PONTE
5011 15TH AVE NW | SEATTLE, WA 98144
3032087

EARLY DESIGN GUIDANCE 2 MEETING

MEETING DATE:
October 22nd, 2018, 8:00pm

5011 15TH AVE NW APARTMENTS

NW Aerial at EDG.1

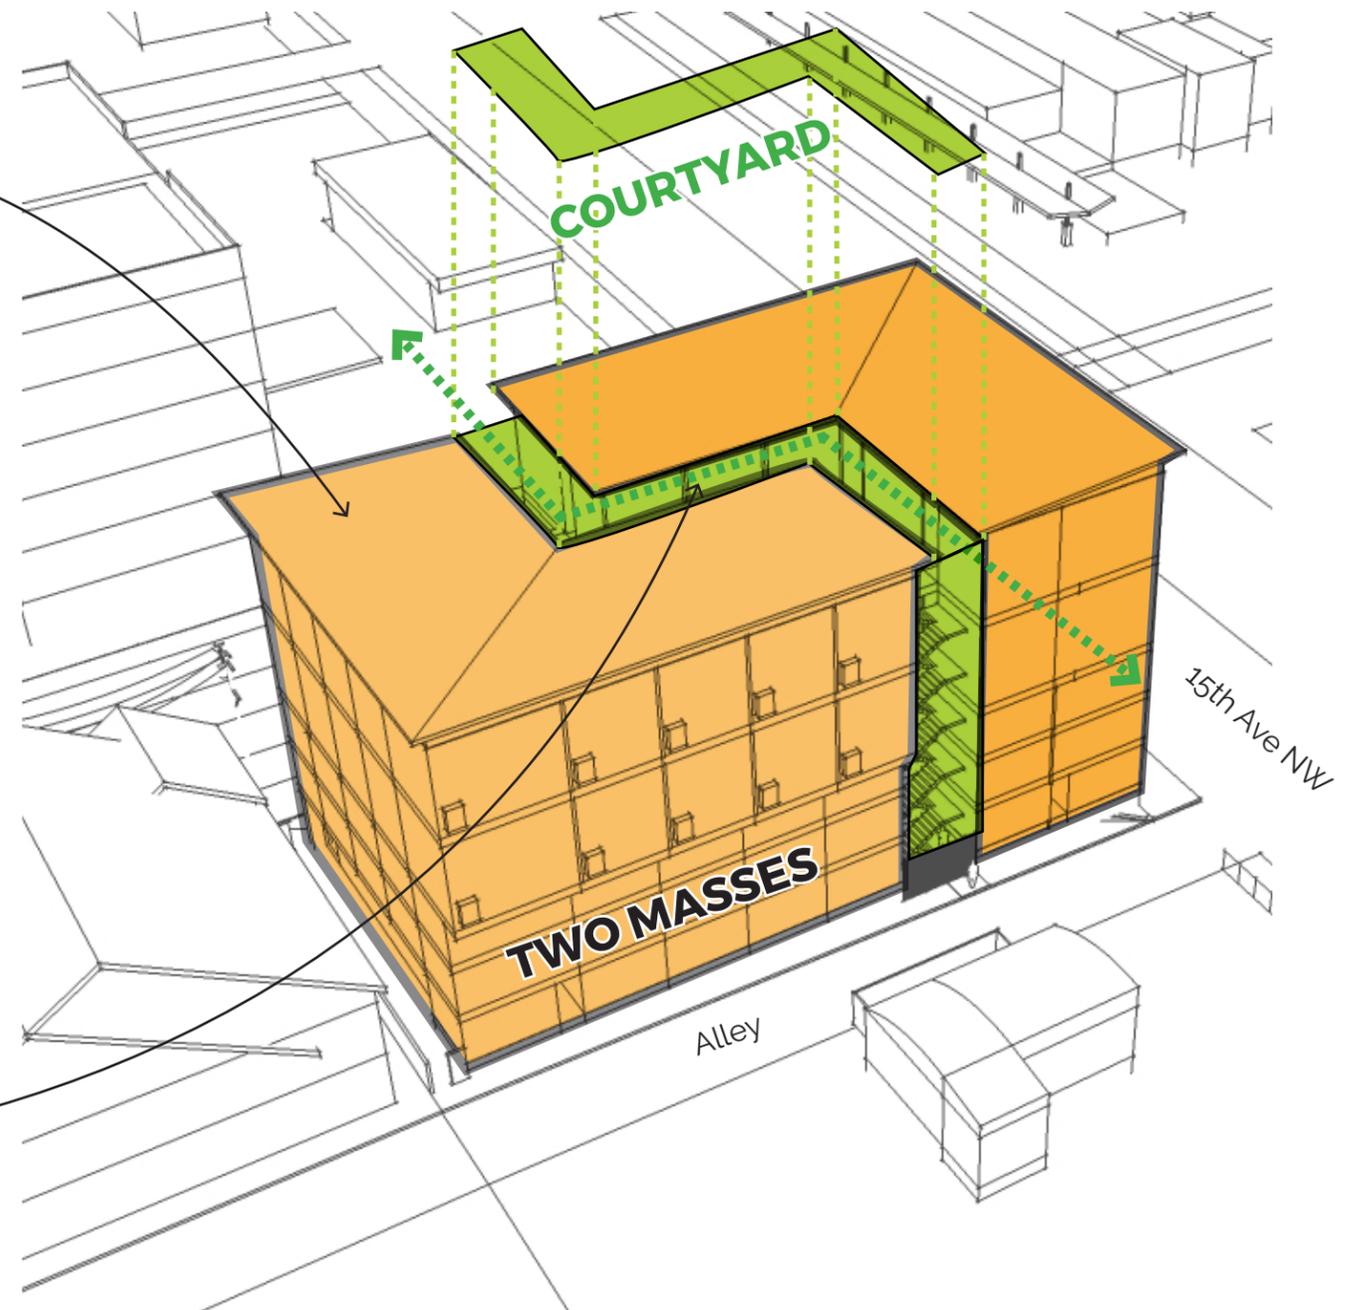
a. The Board noted the severe wall condition proposed on 15th Ave NW as well as the high visibility of the façade and gave guidance to break down the boxy character and further articulate the mass, which could include lowering the height. (DC2-A-2 Reducing Perceived Mass, DC2-B-1 Façade Composition)

b. The Board observed that the signage feels applied to the façade and provided guidance to integrate the signage with the design concept and create a cohesive façade composition. (DC2-B-1 Façade Composition, DC4-B Signage)

c. The Board discussed the material cladding strategy described on pg. 26 of the EDG packet and questioned whether the materials for each L-shaped volume should be more related. The cladding relationship of the two masses should be further studied. At the Recommendation phase the Board expects to review a fully developed concept for the exterior cladding. (DC4-B-1 Exterior Finish Materials, DC2-B-1 Façade Composition)

EDG#1

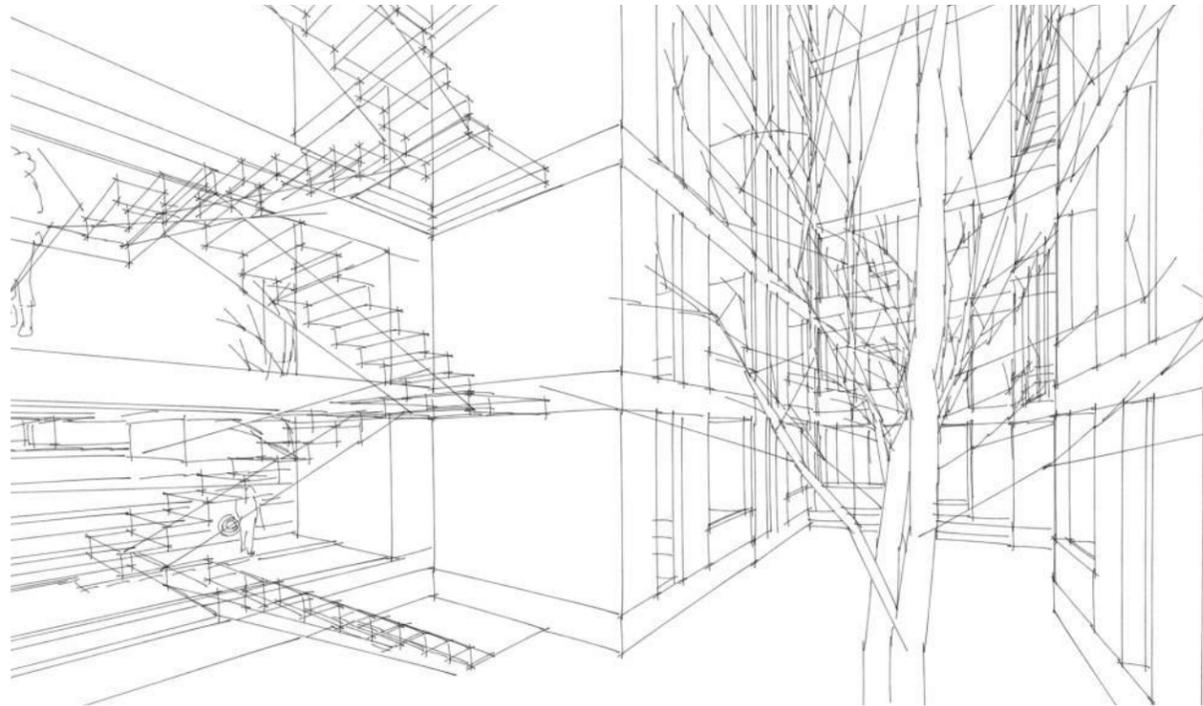
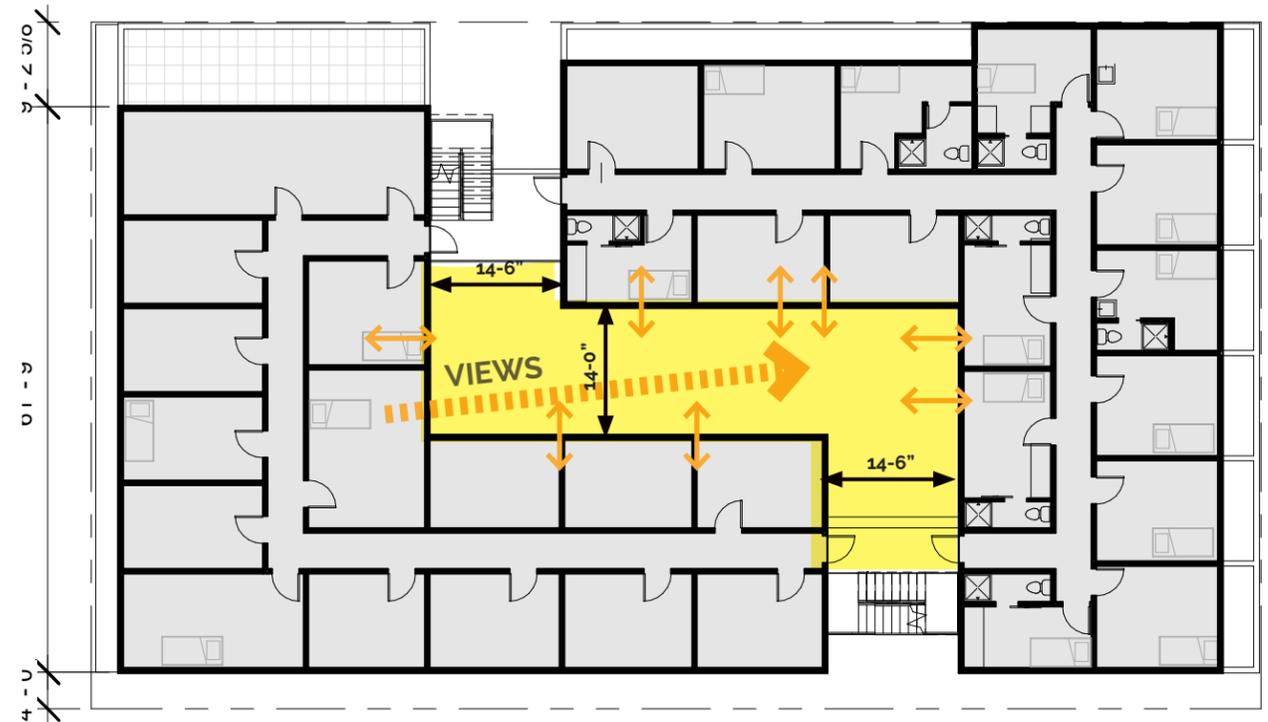
The Board requested **additional study** to further articulate the massing and to develop a wider courtyard for the building.

Ground floor lowered to meet grade to allow for higher ceiling height in common space and more light and air into the courtyard. The result is also a more direct and engaging connection to the sidewalk.

ADDITIONAL STUDY: ARRANGEMENT OF GROUND FLOOR USES

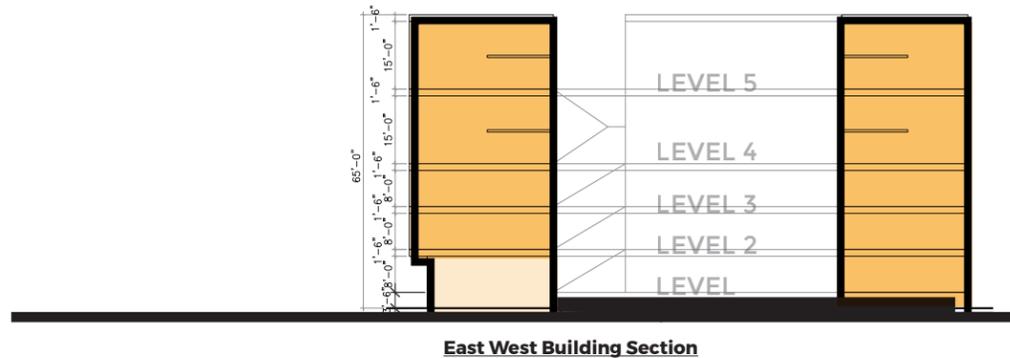
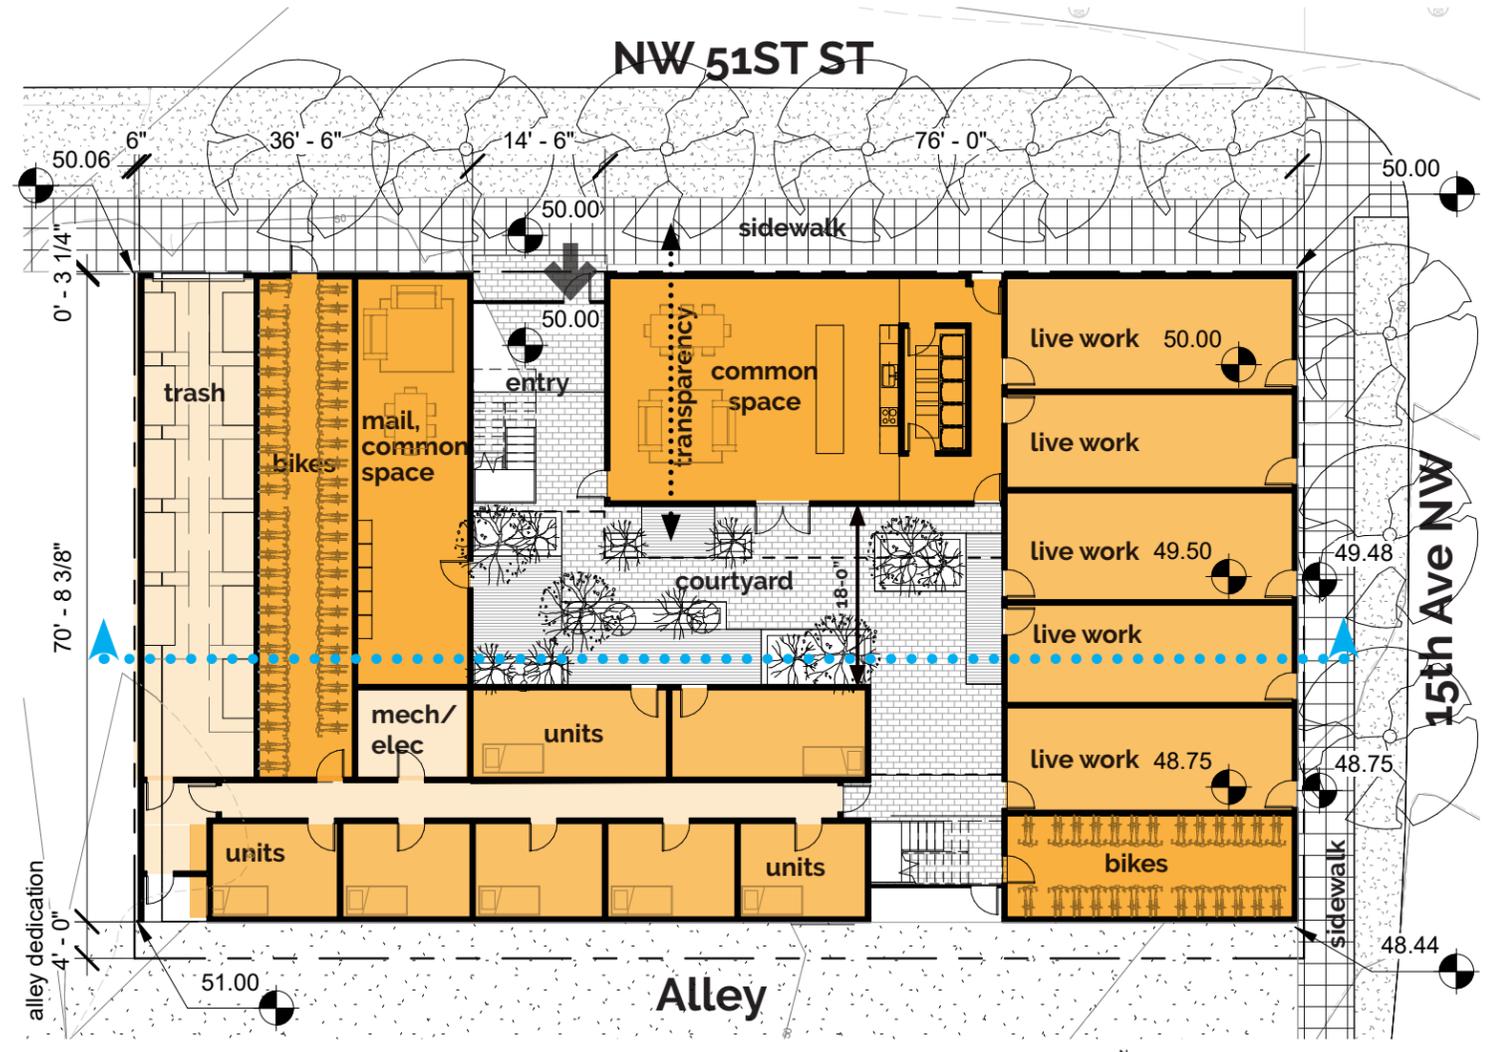
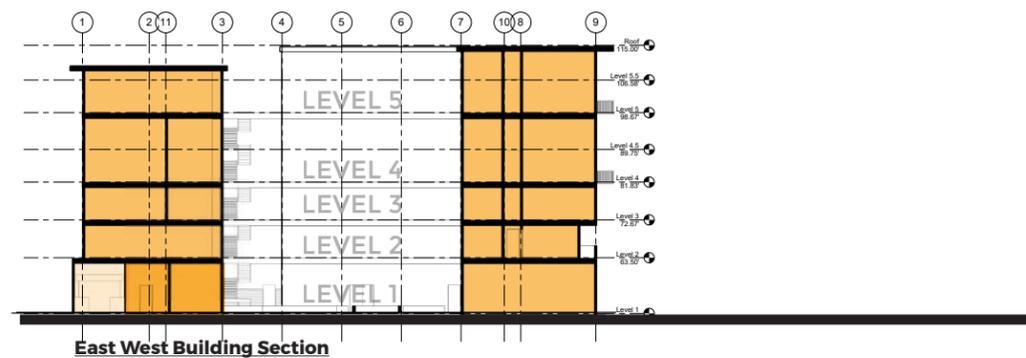
EDG Comment: 3. Arrangement of Ground Floor Uses & Street Level Activation:

Board was concerned with privacy, noise and air quality impacts for ground level residential units along 15th Ave NW and the alley. The Board provided guidance to resolve the ground plane design to mitigate these impacts for ground level residential units.

Active uses, Live Work replaces units along 15th Ave NW to interact with the street frontage. This significantly reduces the impact of street noise on residential use at grade.
